## Proposal for amendment to ECE/TRANS/WP.29/GRSG/2019/32

The text reproduced below was prepared by the expert from the European Association of Automotive Suppliers (CLEPA) to add a missing footnote and to clarify the application of Annex 4 for heat pumps. The modifications to the existing text of the Regulation are marked in **bold** for new and strikethrough for deleted characters.

“ Figure 4

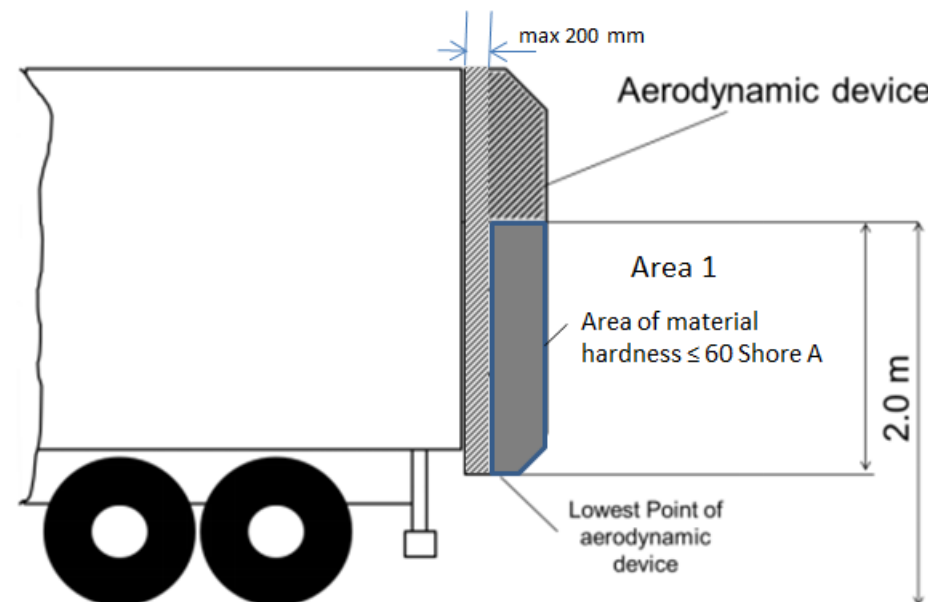
*Annex 8, paragraph 6.2. replace figure 4 by the following :*

1. From technical point of view it is necessary to support the soft area of the device with a frame.
2. Paragraph 6.2. already exempts components (fastenings, hinges, actuators, springs, cables, lamps etc.) from being made of soft material, but current figure 4 may be misleading, that the entire part shall be made from soft material.
3. Following the intention of paragraph 6.1. which exempts from the force test an area of maximum remaining length of 200 mm in longitudinal direction of the vehicle, this “exempted” area should be shown in figure 4 .
